## BULLETIN NO. 2

### 491/20167.SDW - PHASE 500: CENTER FOR FORENSIC PSYCHIATRY- CREATE KITCHEN SALINE, MICHIGAN

WTA Project No. 2021094  
MAY 14, 2025

SPECIAL RECEPTACLES	
TYPE	DESCRIPTION
Type 4	250V, 20A, THREE-PHASE, LOCKING RECEPTACLE, 3 POLE, 4 WIRE (NEMA L15-20R)
Type 8	250V, SINGLE-PHASE RECEPTACLE, 2 POLE, 3 WIRE (NEMA 5-20R)

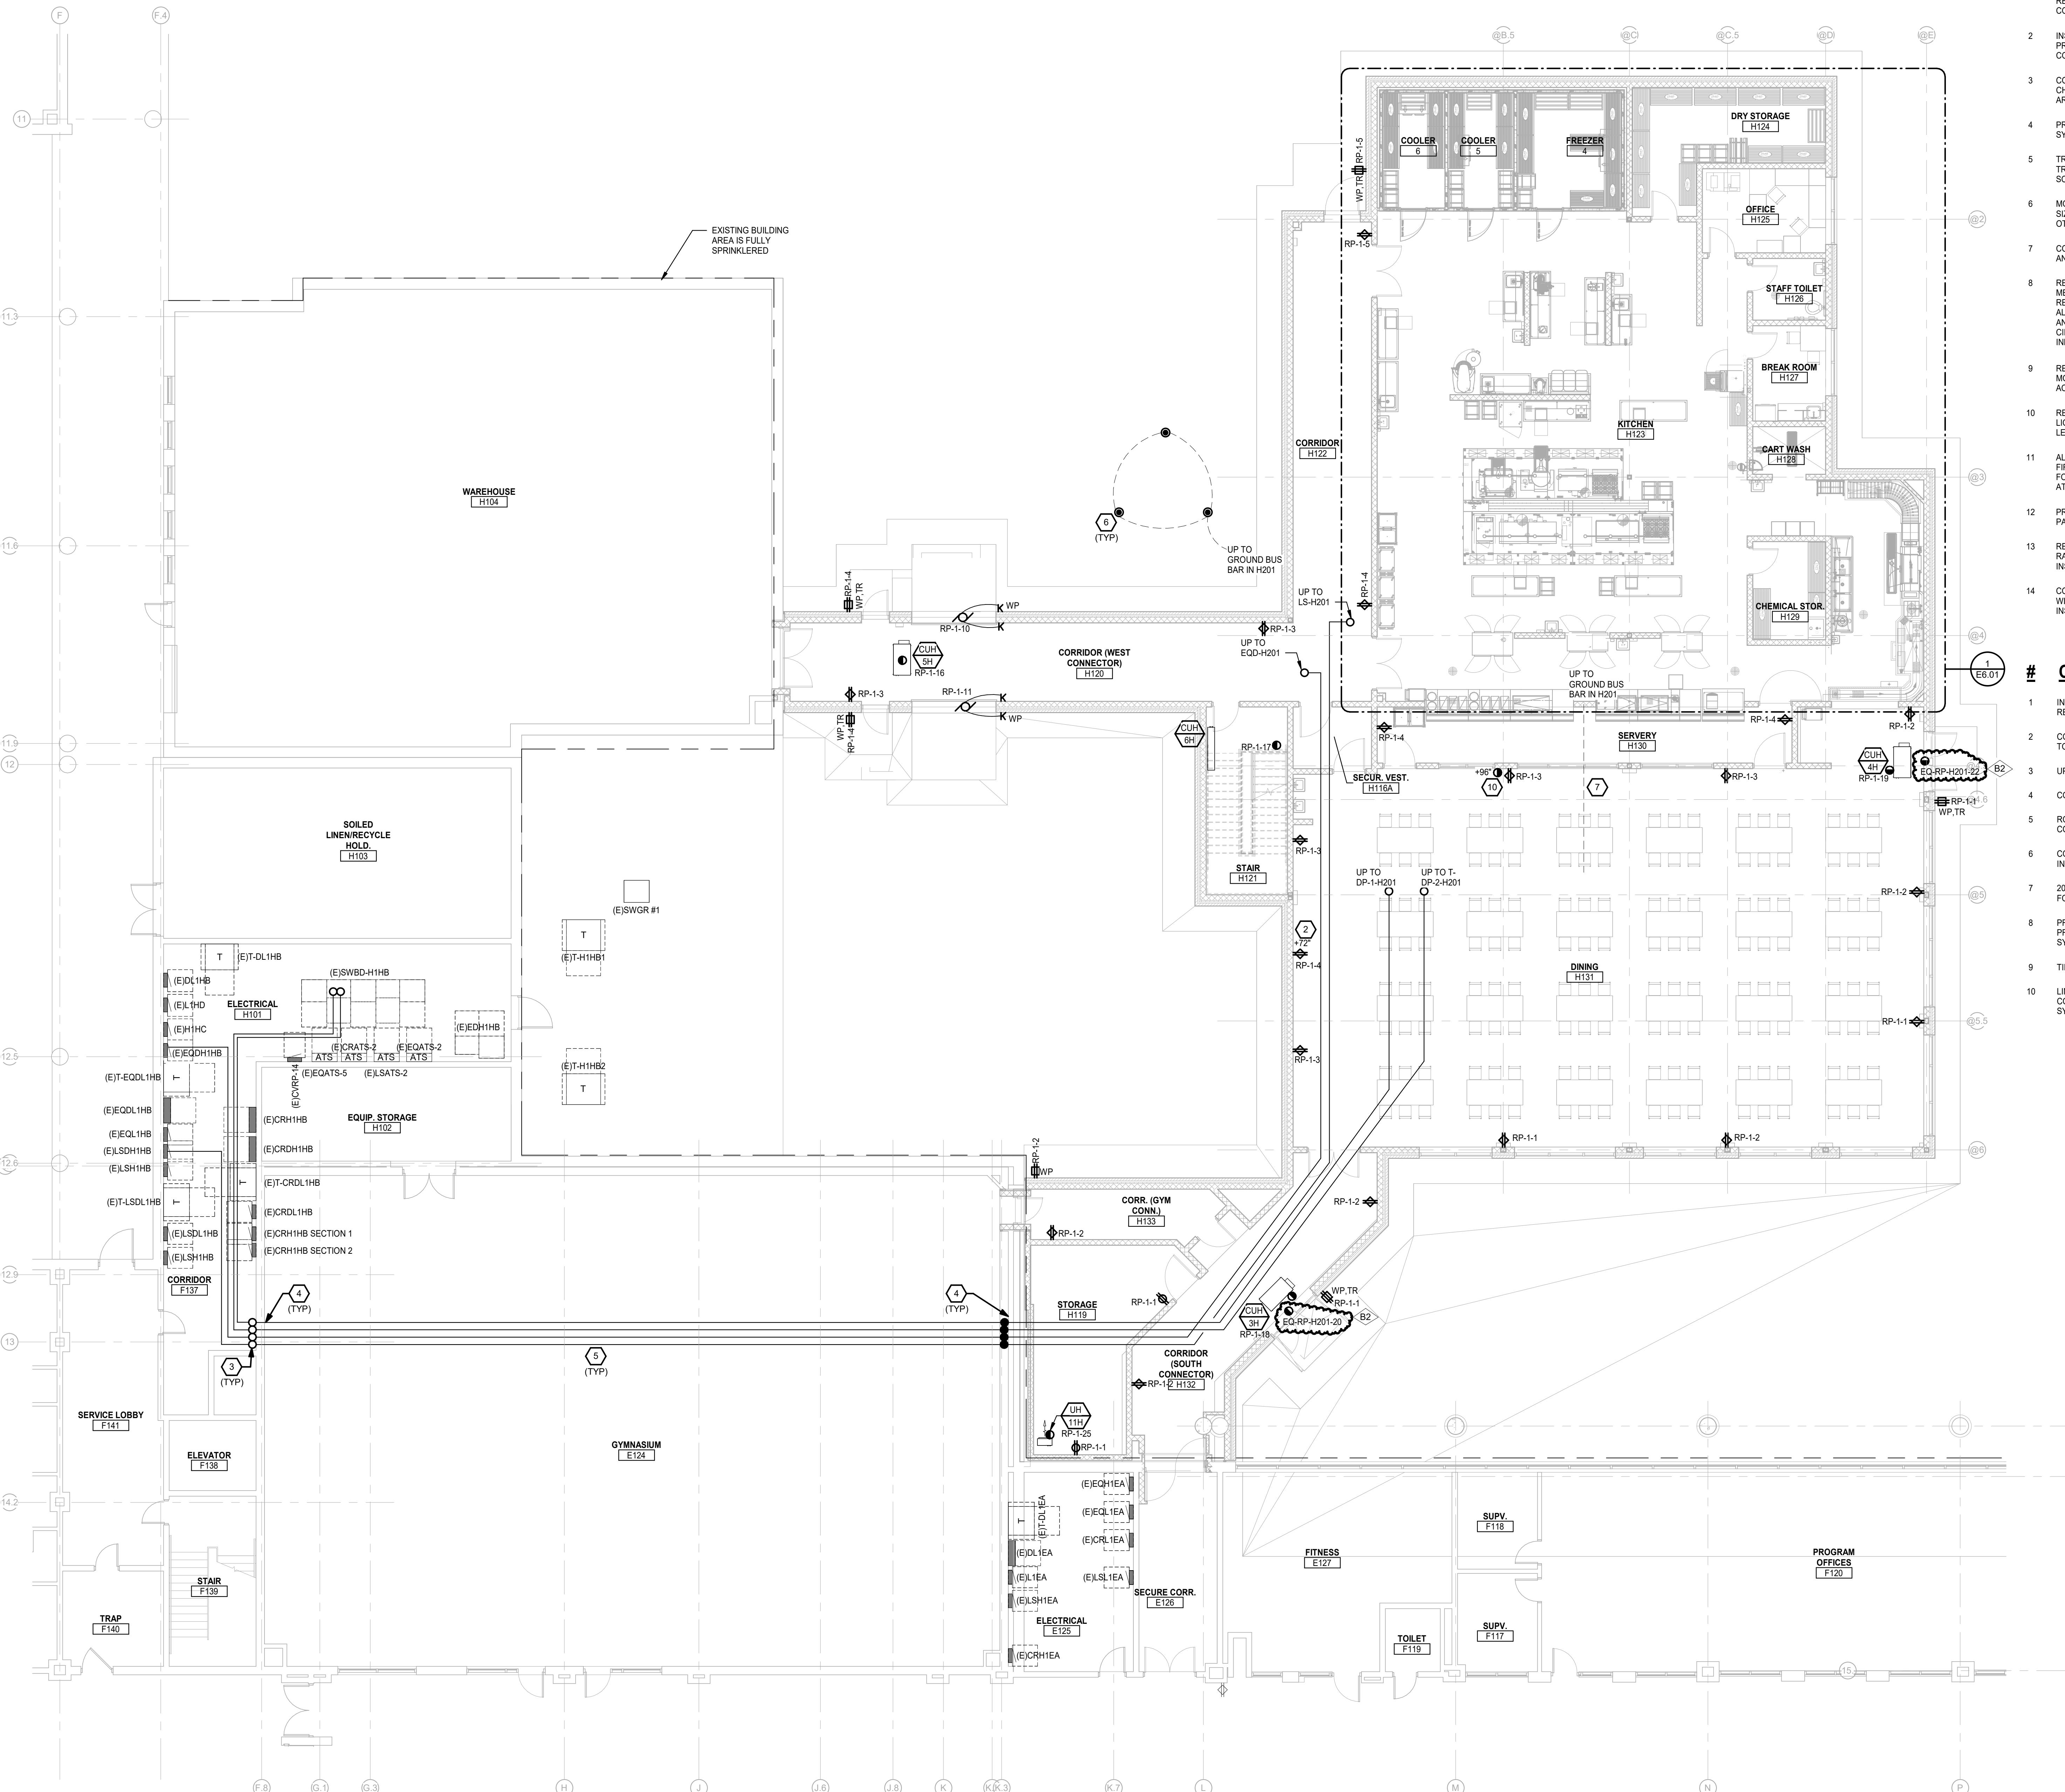
Item E1      Reference Sheet E0.02 (**Re-Issued**)  
A. Revise the receptacle description for type 8.

SHEET TITLE  
FIRST FLOOR AUXILIARY  
SYSTEMS PLAN - UNIT H

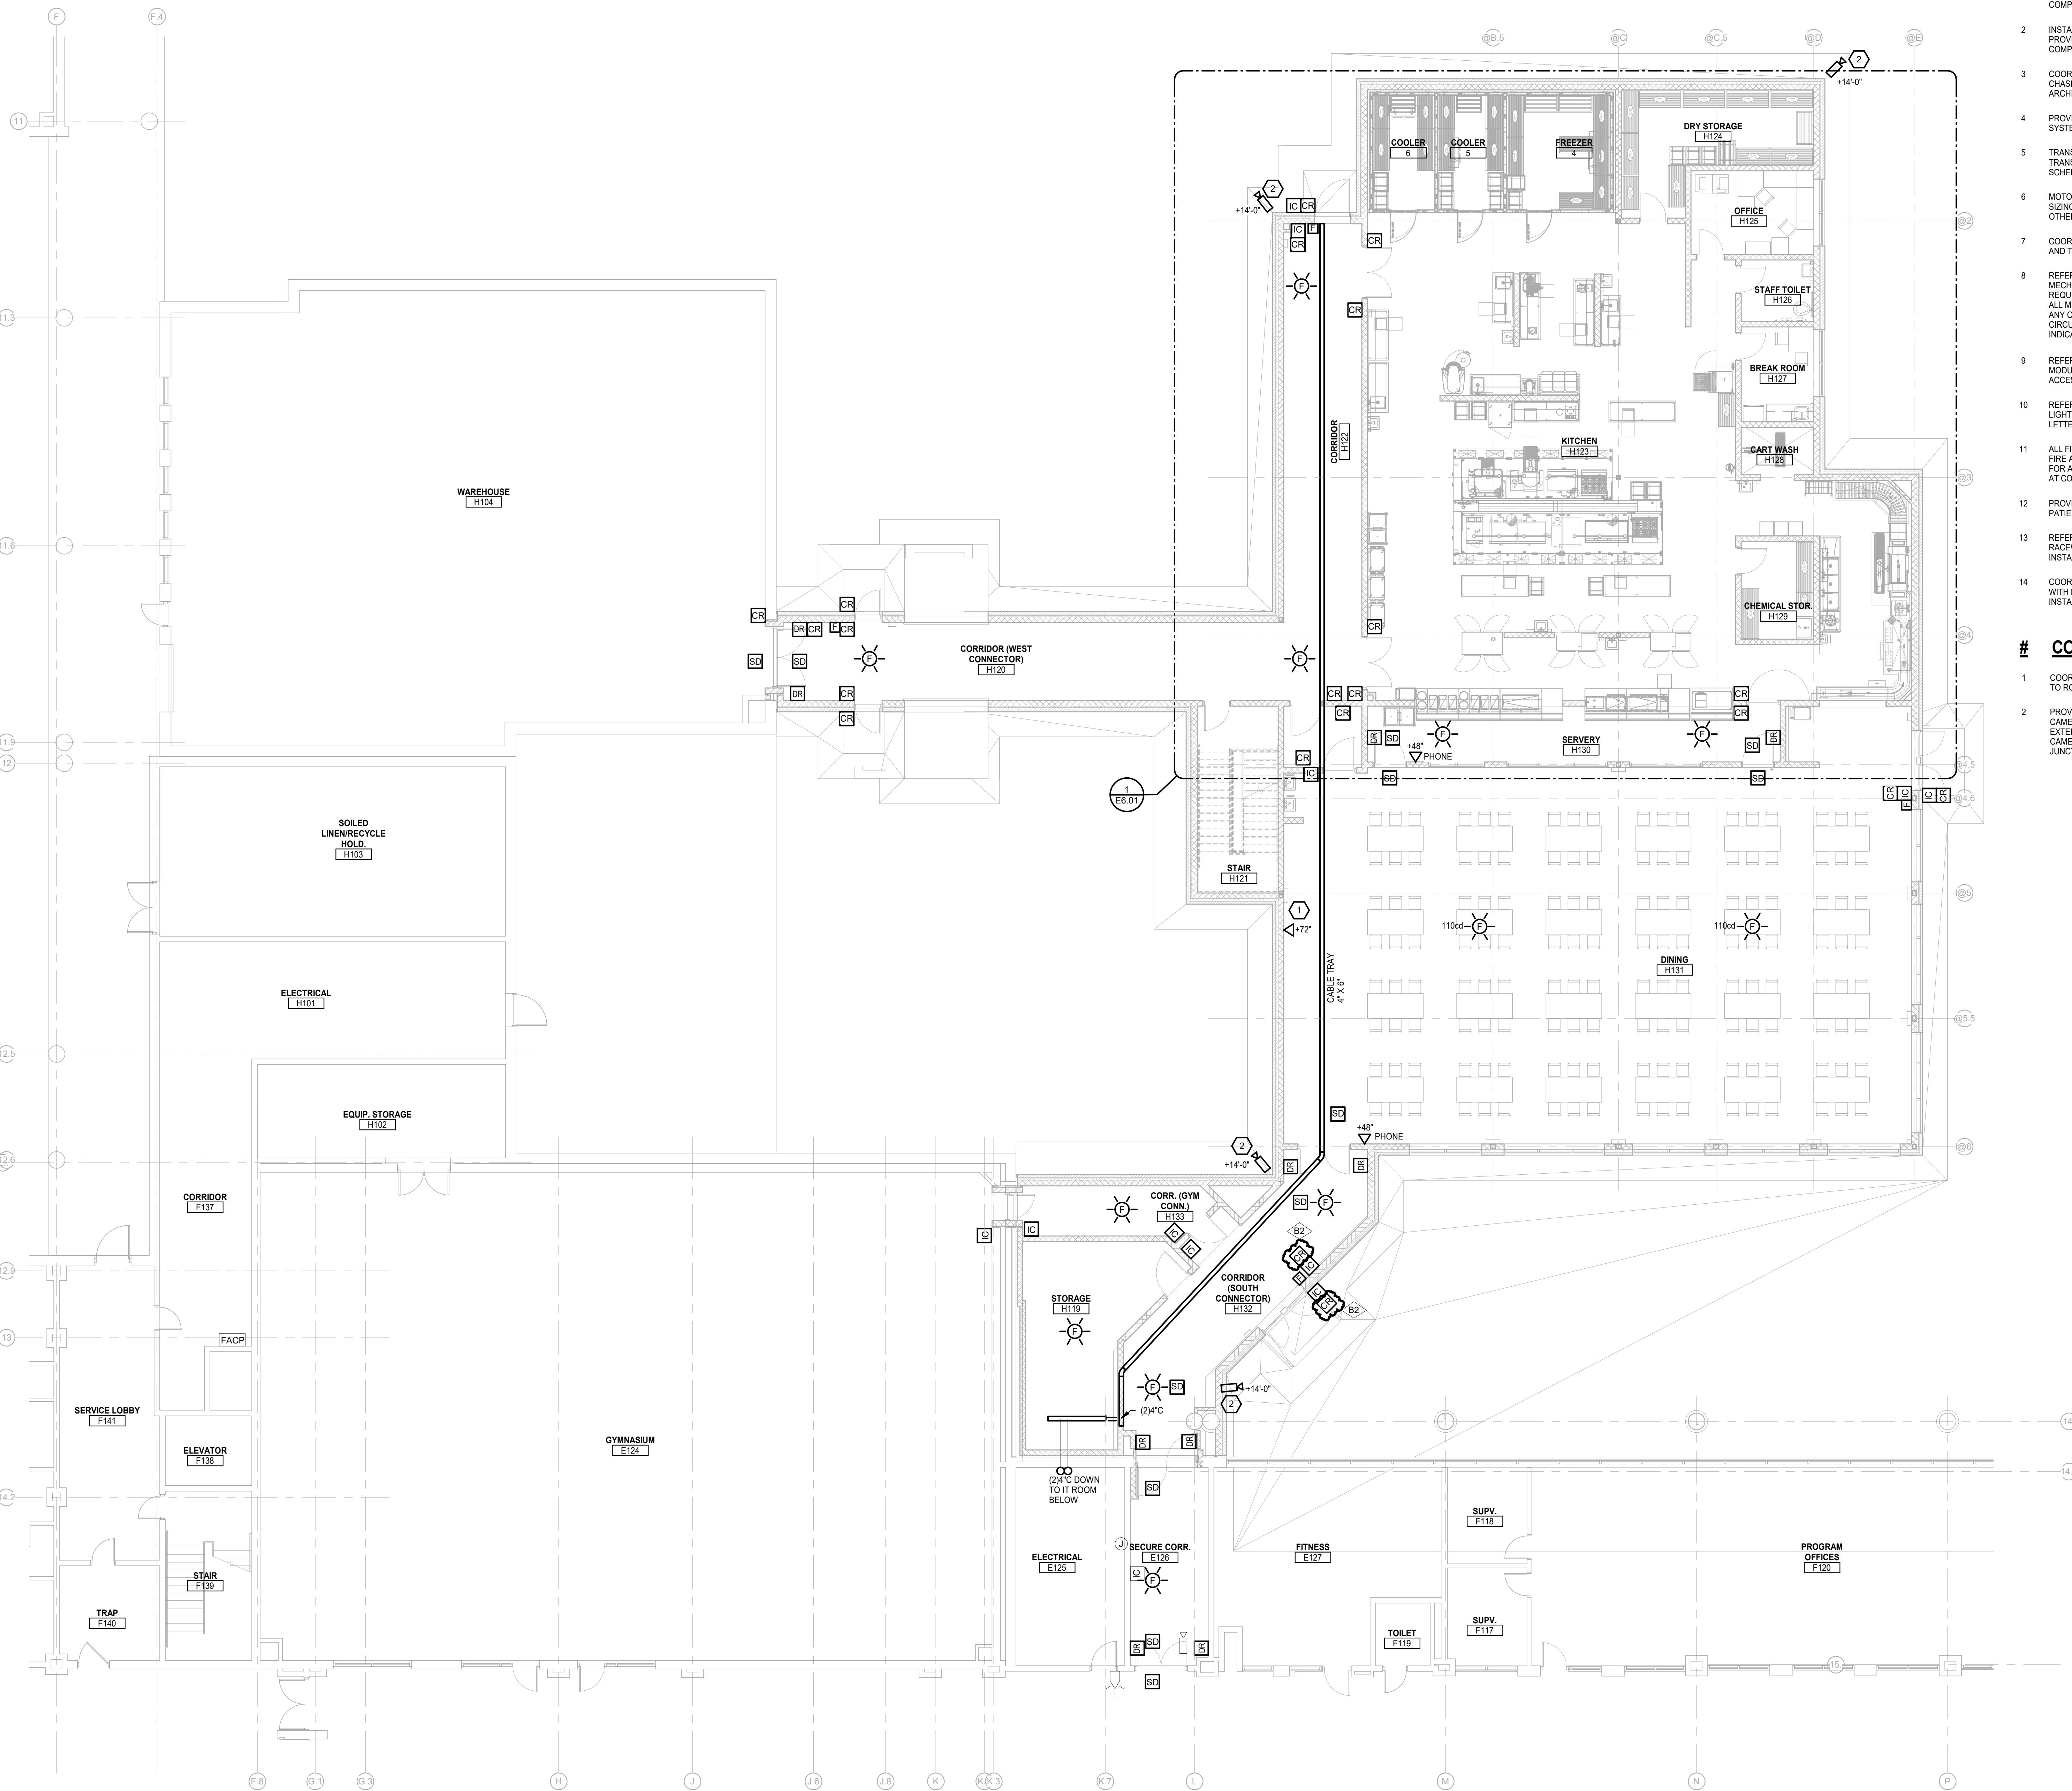
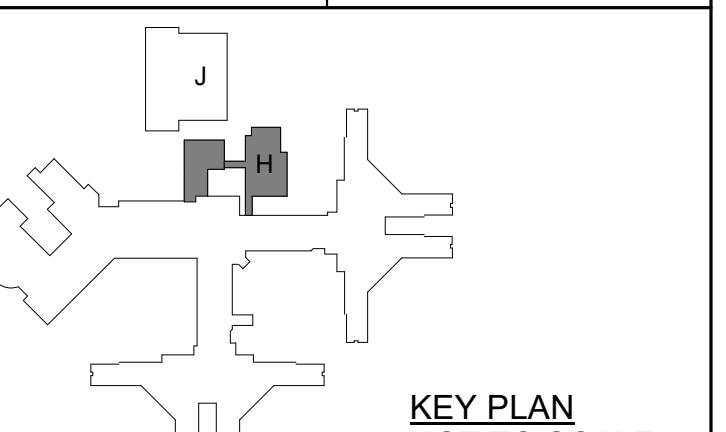
Item E3      Reference Sheet E4.01 (**Re-Issued**)  
A. Add card readers to the interior and exterior at door H132.C
